TECHNICAL EVALUATION REPORT
ST. LUCIE UNIT 1
STATION BLACKOUT EVALUATION .

TAC No. 68608

Final
August 17, 1990

U.S. Nuclear Regulatory Commission
Washington, D.C. 20555

FIGURE 1

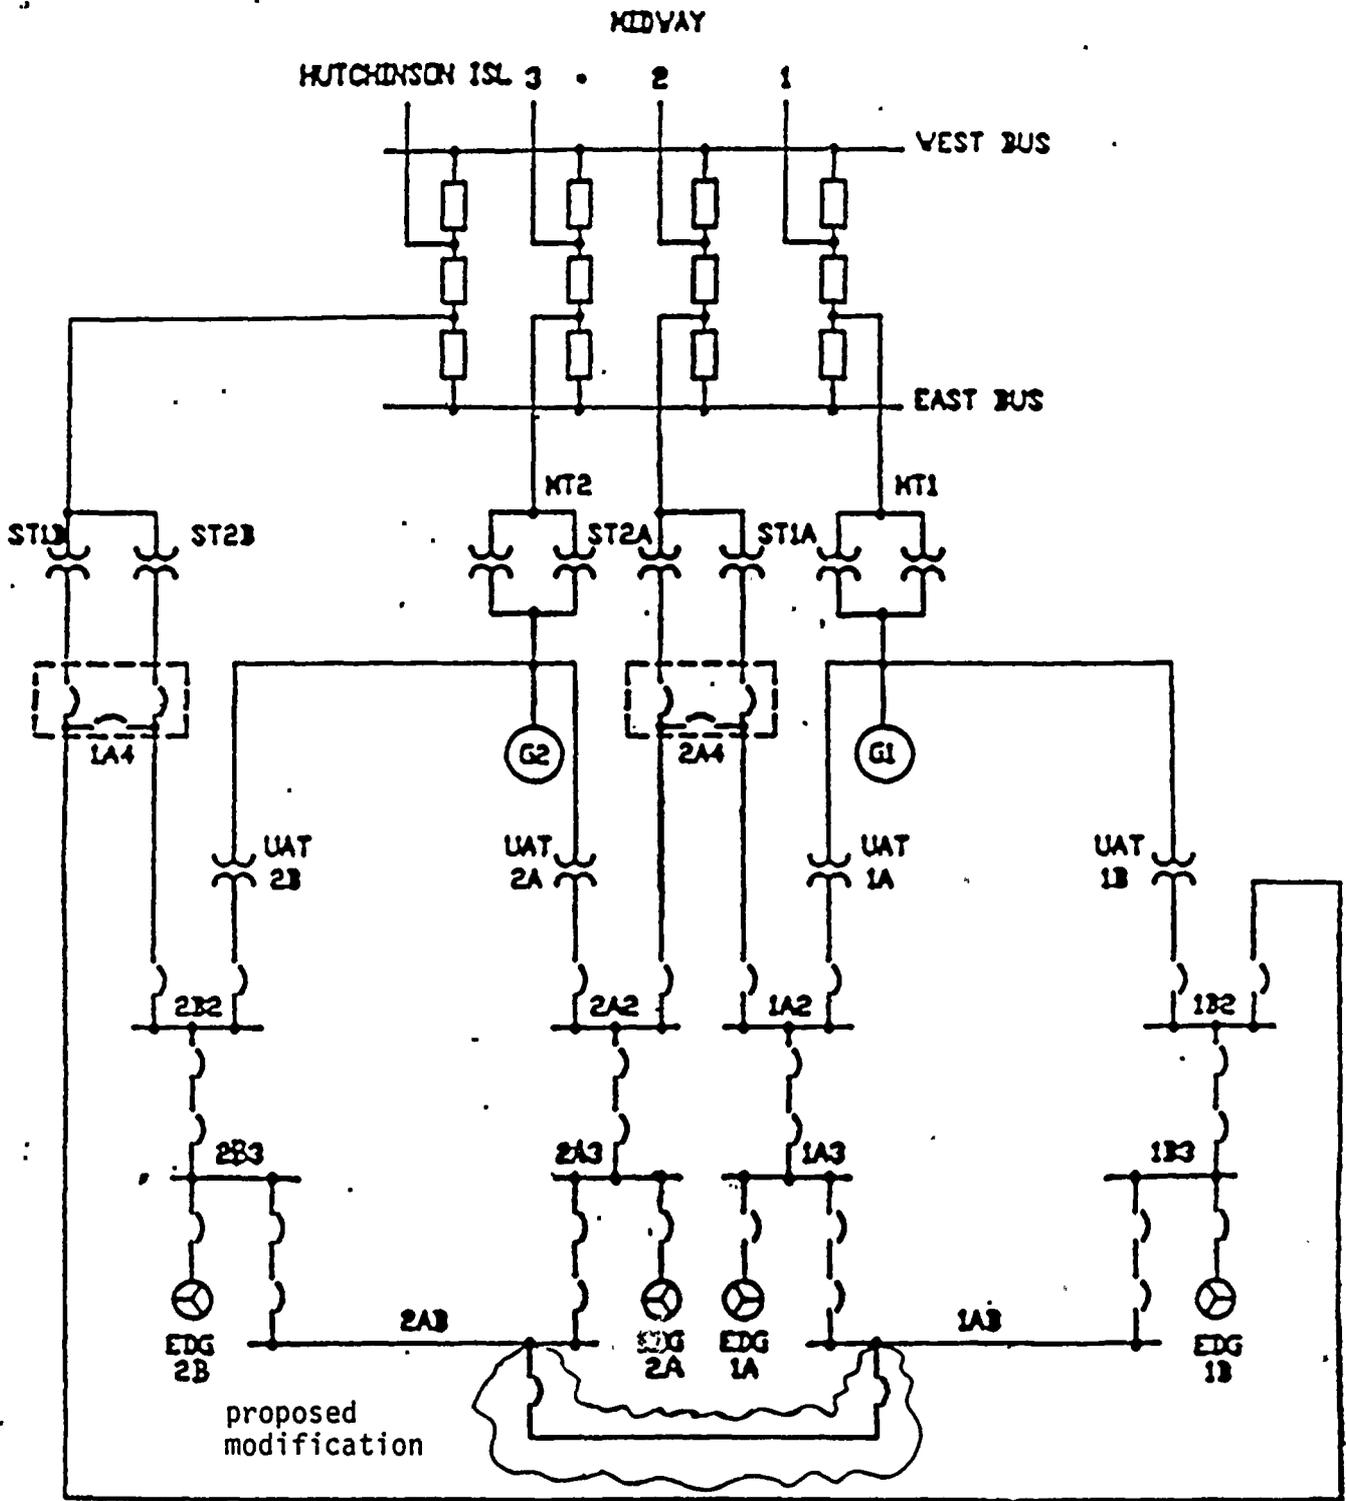
1. Upon the loss (failure) of one start-up transformer (ST1A or ST1B), a manual transfer (through 1A4 or 2A4) is available to the Unit 2 start-up transformer (ST2A or ST2B) of the same train. This manual transfer can be accomplished in 30 minutes.
2. Following a loss of power to a start-up transformer (ST1 or ST2), the connected emergency bus in Unit 1 can be powered from one of the emergency buses in Unit 2 through the proposed class 1E cross-tie modification between the units.

Based on the above, we agree with the licensee that this configuration could place St. Lucie Unit 1 in group "I2" provided that each start-up transformer and unit auxiliary transformer has sufficient capacity to supply the loads on one division of buses in one unit and one division of emergency buses in the other. Otherwise, an "I3" offsite power grouping should be considered.

The proposed modification entails adding class 1E 4.16 kV breakers and buswork to tie the existing safety-related swing buses (1AB and 2AB) of the two units. (See Figure 1) The licensee stated that since each swing bus is capable of receiving power from either of the EDGs in that unit, at least one swing bus is always assured a source of power. The licensee stated that a safety bus on the blacked out unit could then be reenergized via the proposed cross-tie within ten minutes from the control room. The licensee stated that the modification and associated procedural changes are currently scheduled for the fourth quarter of 1991.
